SERVICE BULLETIN

SB-10059018-3632

ADDRESSEES	: ABC Customer Care and Parts Source Owners and operators of coaches listed under 'Application'
VEHICLE MODEL	: T2145, C2045, CX45
MANUAL SECTION	: Chapter 12.10: Drive axle
BULLETIN TYPE	: Field Change Program
DATE	: September 05th, 2014
SUBJECT	: To change not properly heat-treated axle shafts
TERMS & CONDITIONS	: Refer to the warranty section further in this Bulletin.

Procedure: Axle shaft change out procedure

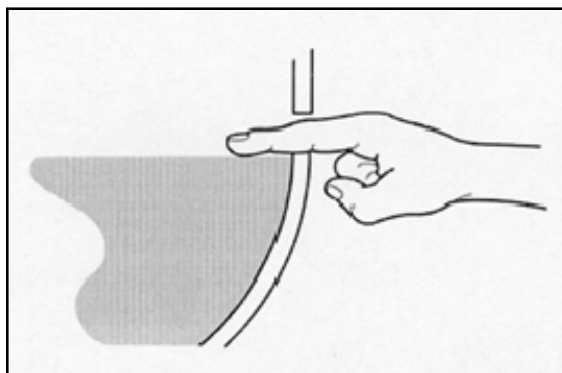
- Axle manufacturer Dana has informed Van Hool of a quality issue on the axle shafts of some drive axles. The affected axle shafts have been incorrectly heat treated what can result in early failure if the shafts are subjected to extreme or adverse operating conditions.
- To address this issue, Dana and Van Hool are conducting a field change program to replace these axle shafts. Terms and conditions are explained further on under "Warranty".
- Owners and operators of the affected units should replace the axle shafts.
- Refer to the step-by-step instructions explained in this Service bulletin.

1. Remove the 8 x Verbus Ripp retaining screws securing the axle shaft to the hub.
2. Place a drip tray or spill cloth under the flange end of the axle shaft to catch any oil which may be lost as the axle shaft is extracted.
3. Insert 2 x M10 x 1.5 “jacking screws” into the 2 threaded holes in the axle shaft flange. This will pull the axle shaft flange away from the hub face.
4. Pull the axle shaft from the axle.
5. Clean the face of the hub and apply a thin bead of soft sealant (Loctite 518 or similar).
6. Identify the correct position of the axle shafts. On the figure below it is shown that the shorter shaft part No.834203 is fitted at the LH side of the vehicle/axle. The longer shafts part No.834202 is fitted at the RH side of the vehicle/axle.

7. Insert the new axle shaft into the axle, aligning the axle shaft splines with the differential side gear. Some rotation of the axle shaft will be necessary to align the splines.

8. Fit the 8 x Verbus Ripp axle shaft retaining screws and tighten to a torque of 314 to 346 Nm (230 to 255 ft.lbf).
9. When both axle shafts have been replaced check that the axle lube is level with the bottom of the filler hole. Top up the axle oil level if necessary.
10. Refit the filler plug and tighten to a torque of 54 to 68 Nm (40 to 50 ft.lbf).
